# Access Compliance Report

## Public Rights-of-Way

### (Curb Ramps)

Intersection ID: 5525	Main Street: W_W_T_HARRIS_BV	Cross Street: MCCULLOUGH_DR	Location: E
ADA ID: A0BC69713C2F	Ramp Type: Perp	Initial Pass/Fail: Fail	Overall Compliance: No
Severity Score: 8.75			
Codes/Mitigation Info/Possible Solution		Field Measurements/Component Compliance

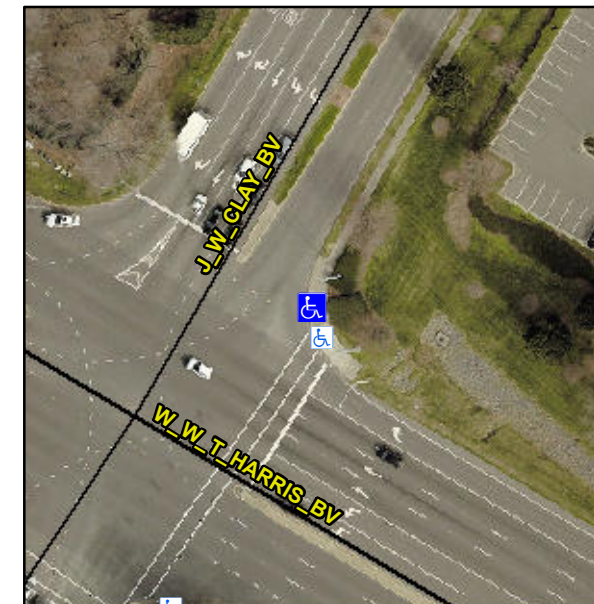
PROW/ADA:

**R304.5.1**

Possible Solutions:

**Remove & Replace Entire Ramp.**
